**TOWN OF NEWBURGH
PLANNING BOARD
TECHNICAL REVIEW COMMENTS**

PROJECT NAME: CHADWICK WOODS – 5 LOT SUBDIVISION
PROJECT NO.: 19-02
PROJECT LOCATION: 174 ROUTE 300
SECTION 14, BLOCK 1, LOT 51
REVIEW DATE: 31 MARCH 2023
MEETING DATE: 6 APRIL 2023
PROJECT REPRESENTATIVE: ENGINEERING & SURVEYING PROPERTIES

C-301

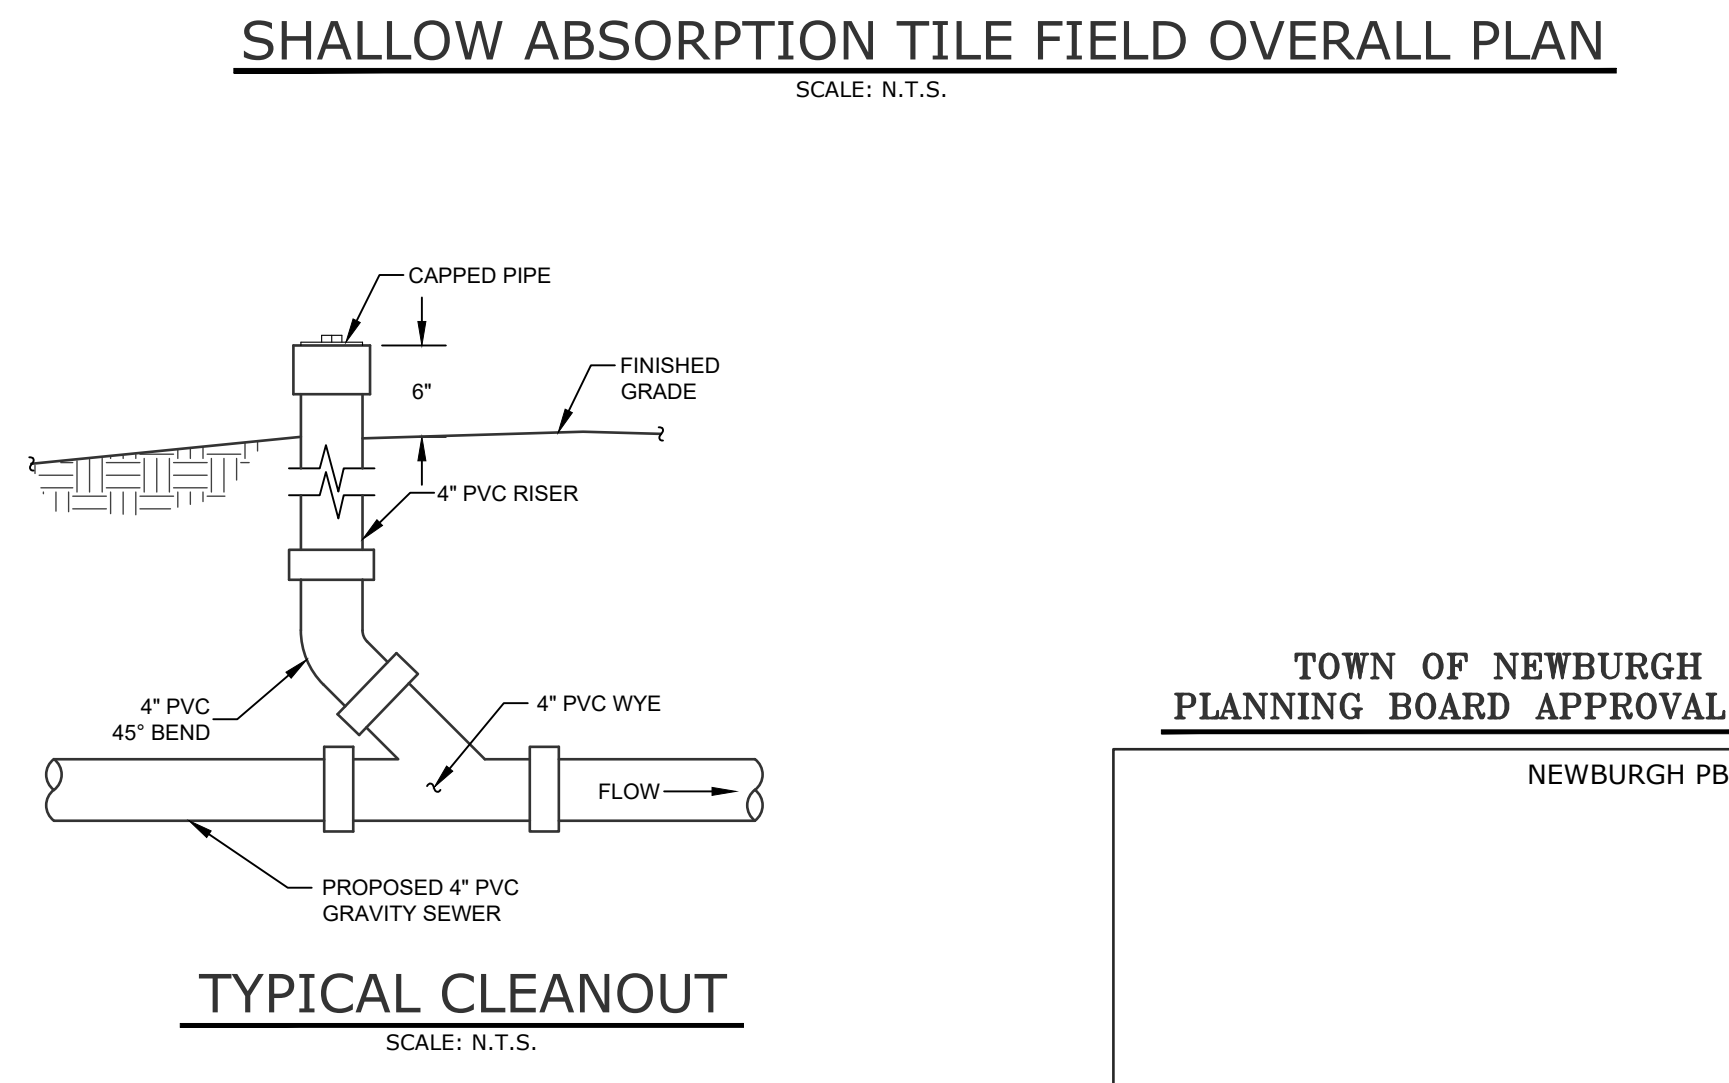
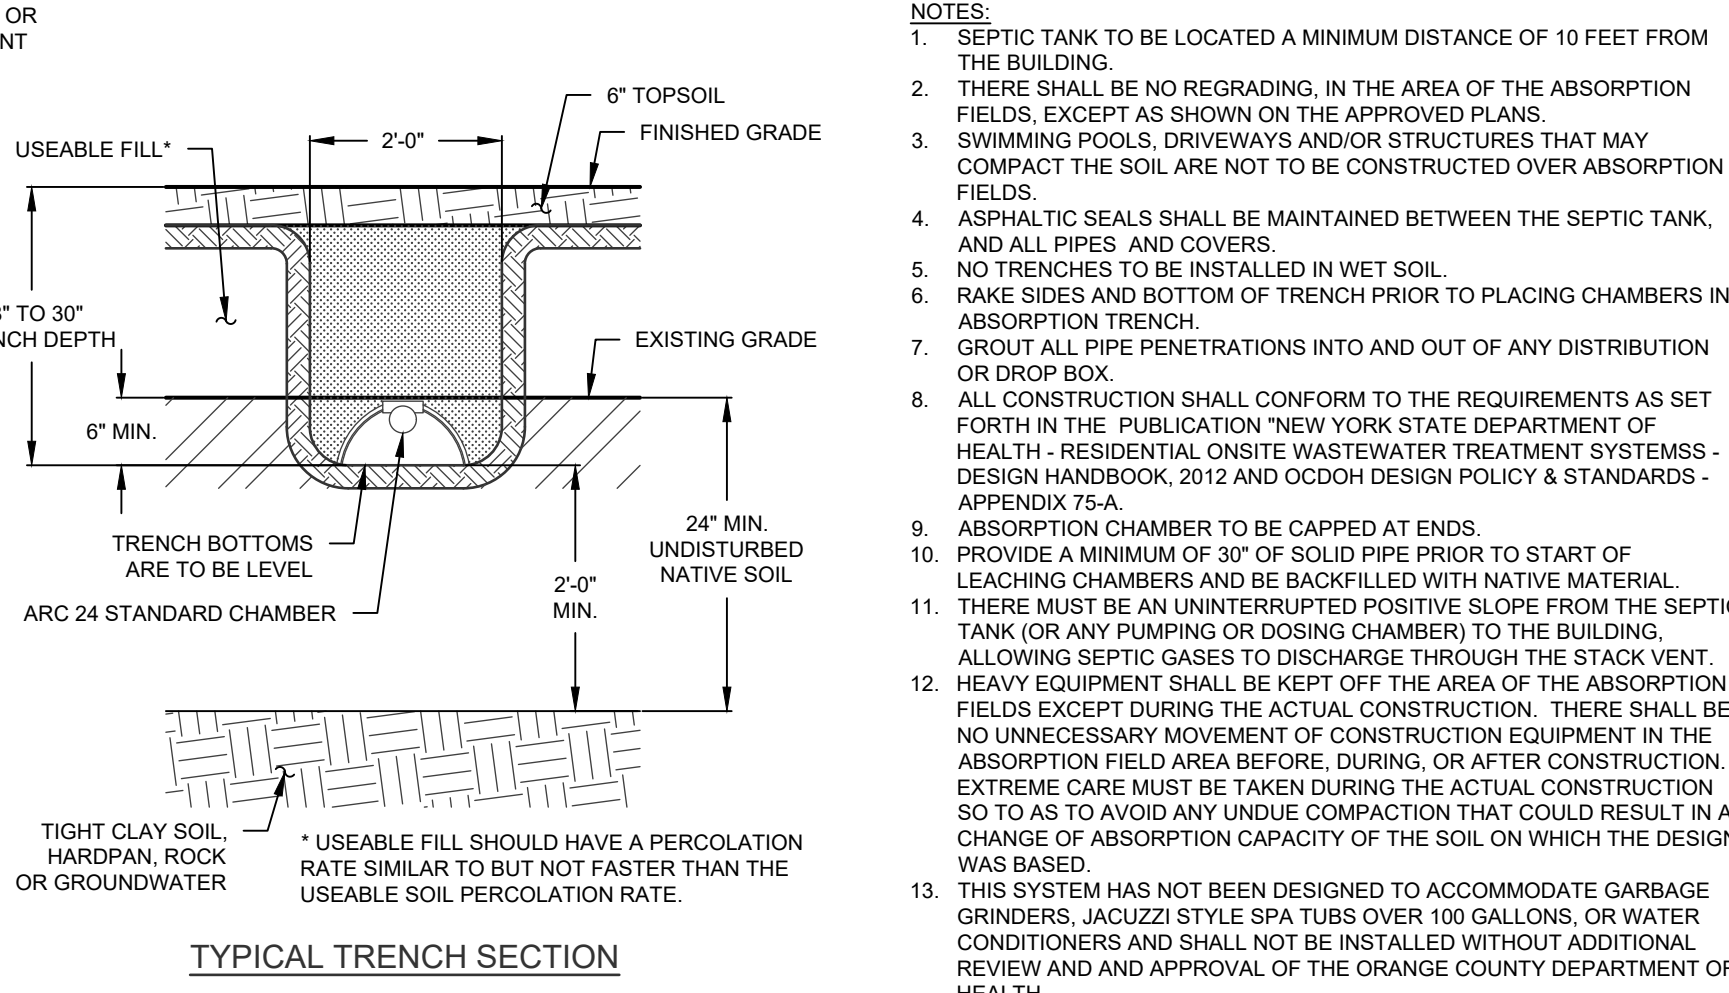
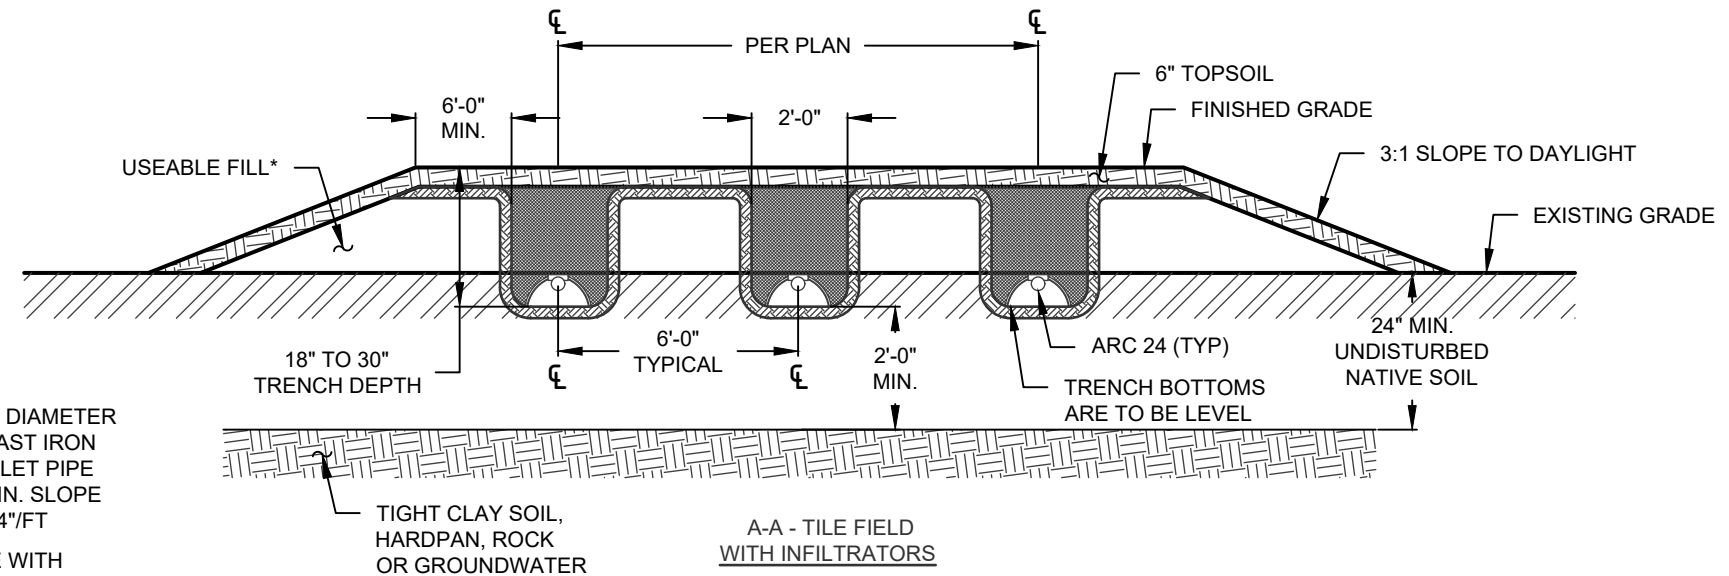
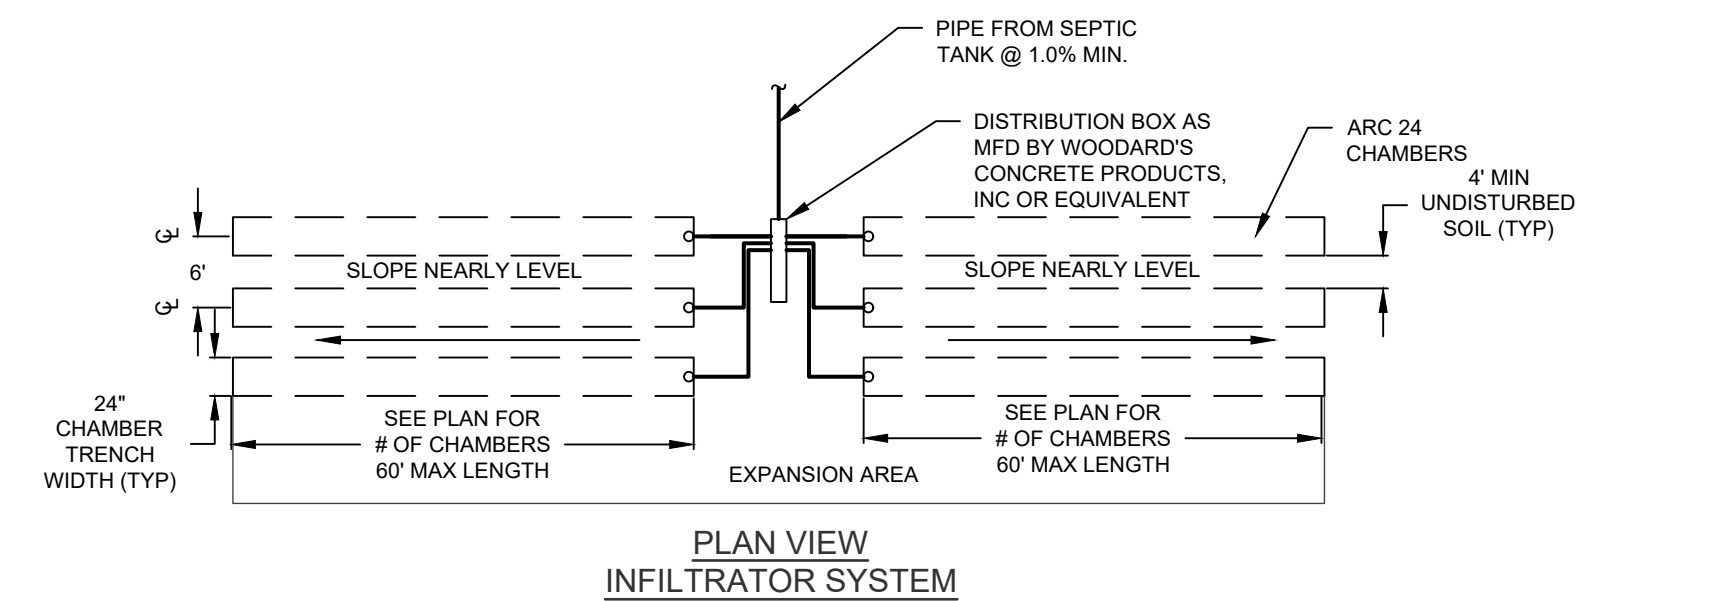
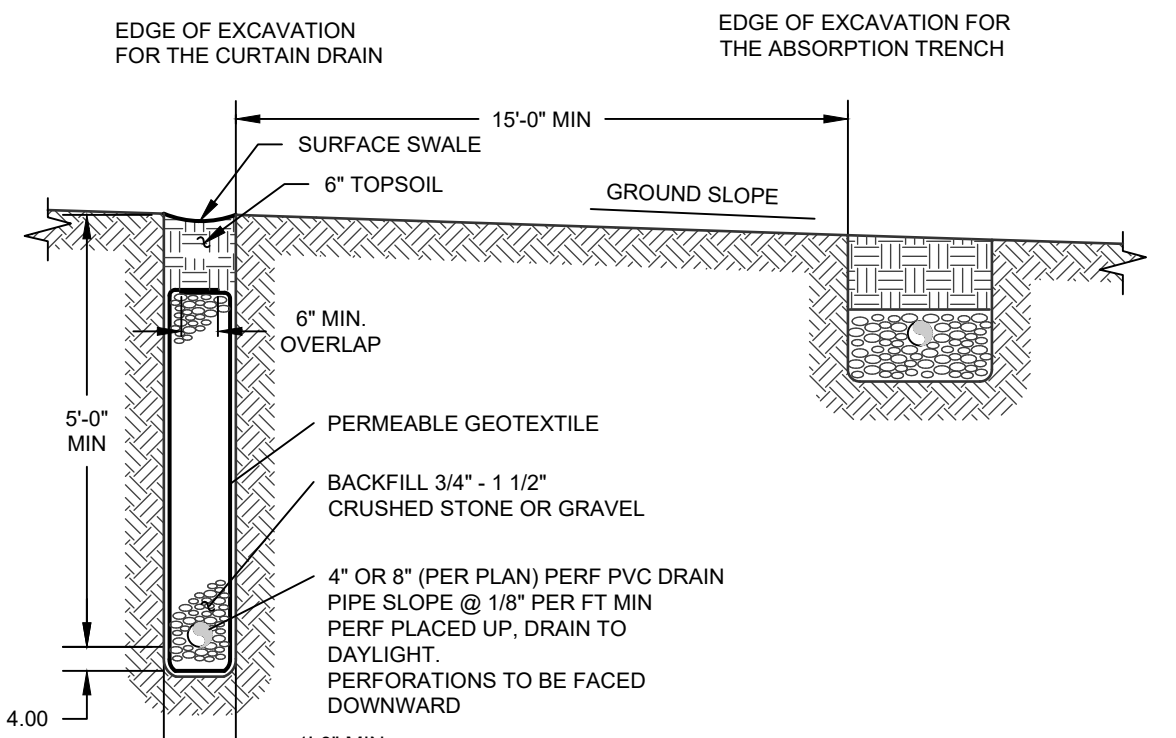
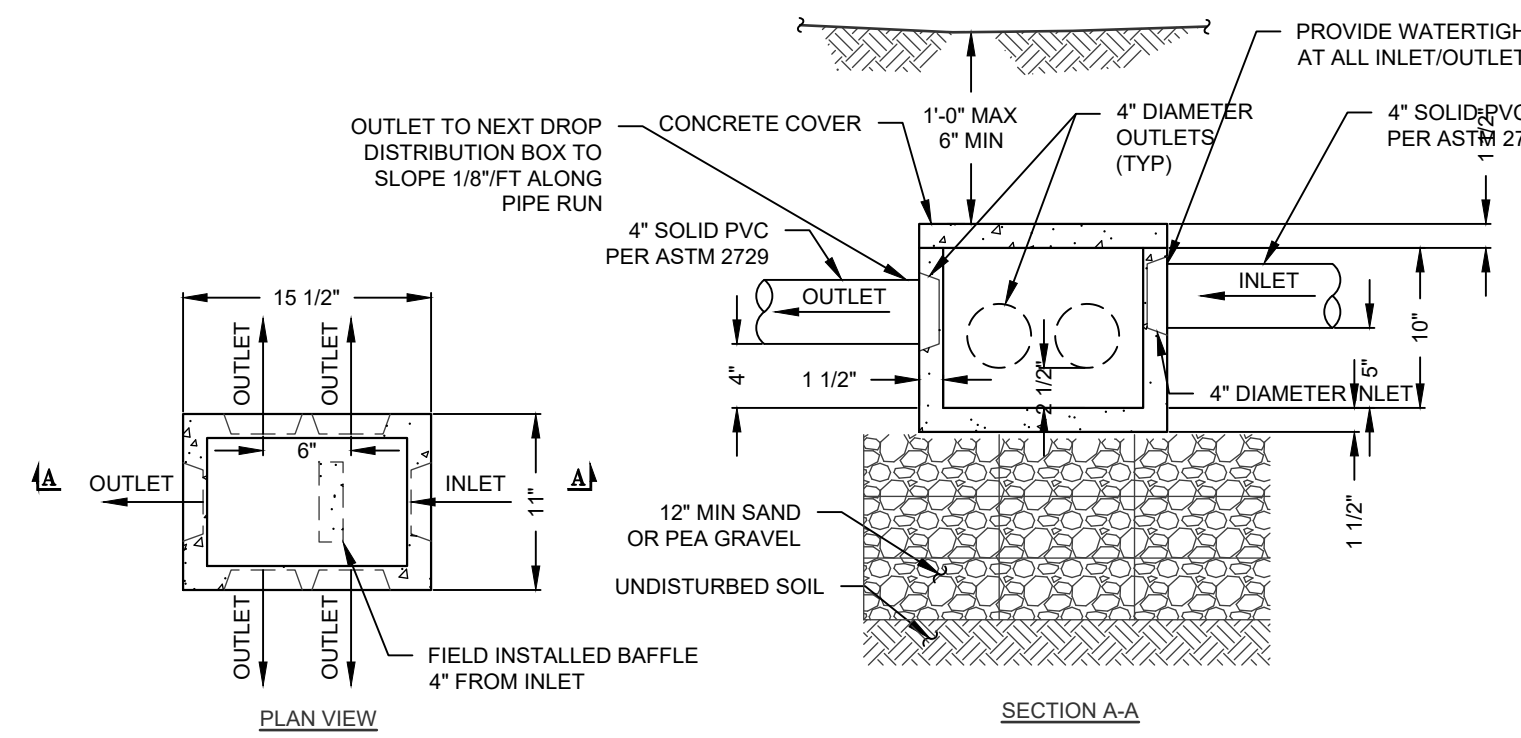
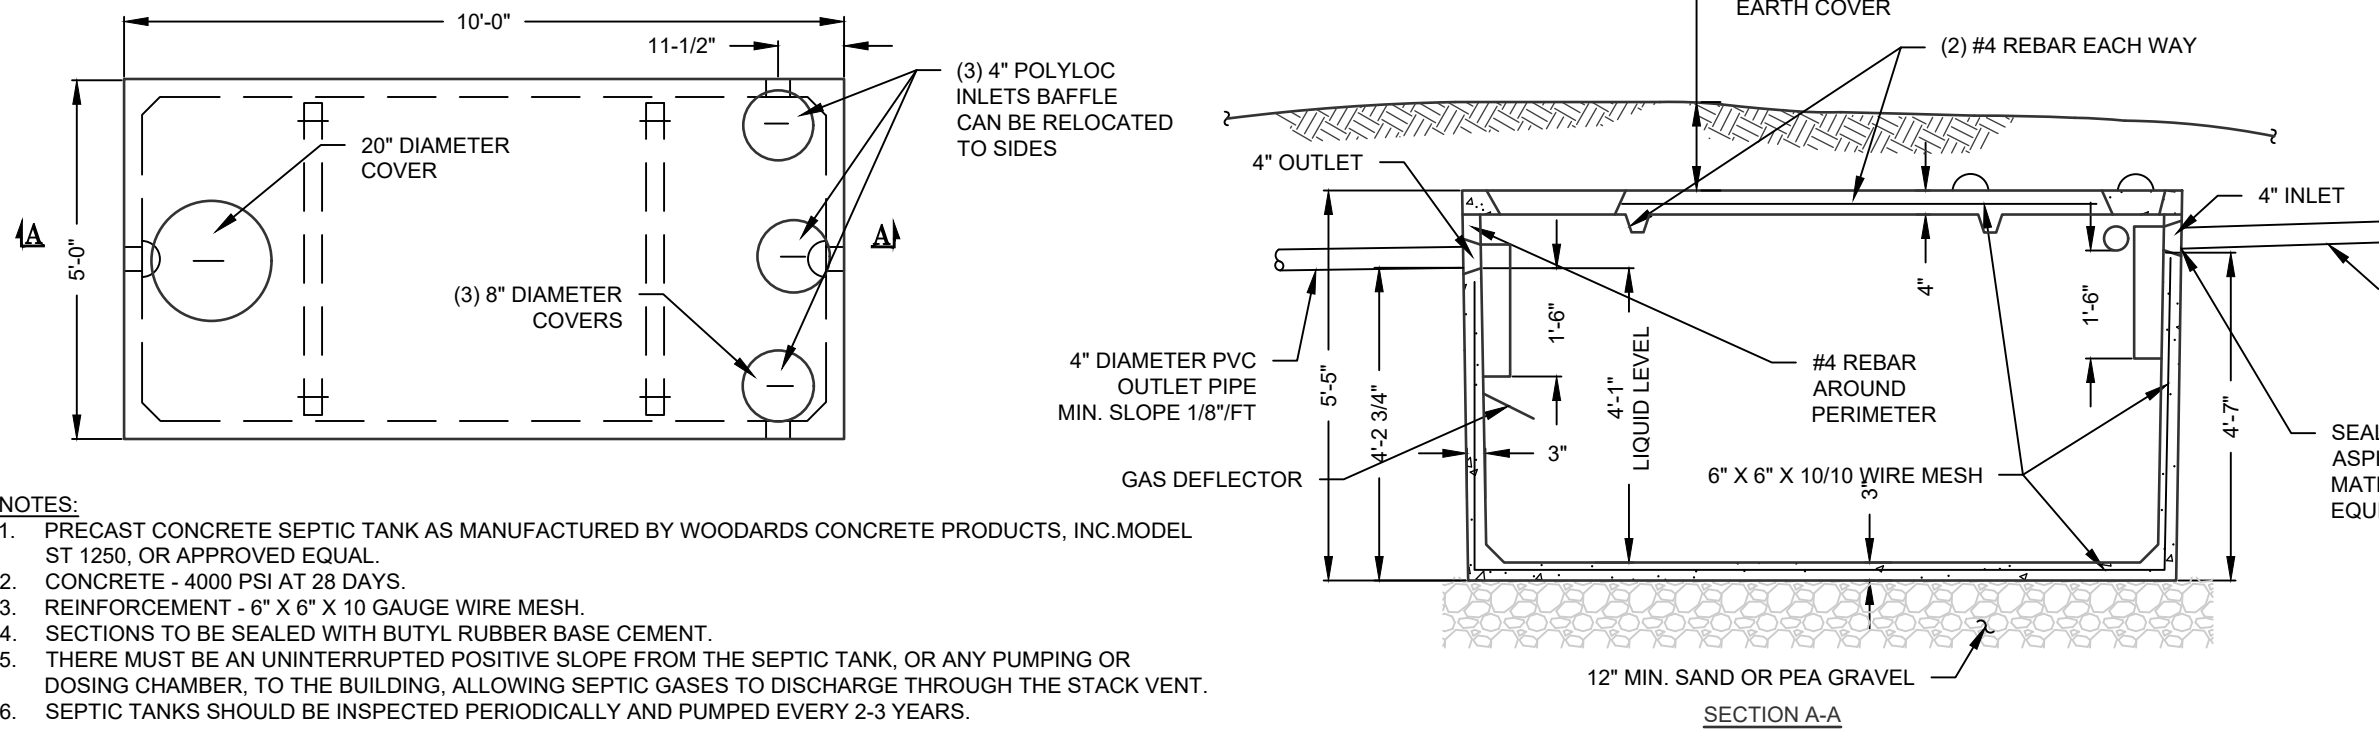
7. The sanitary sewer details conflict with the shallow absorption tile field overall plan detail on Sheet C-301 and the absorption tile field drop box details on Sheet C-302.
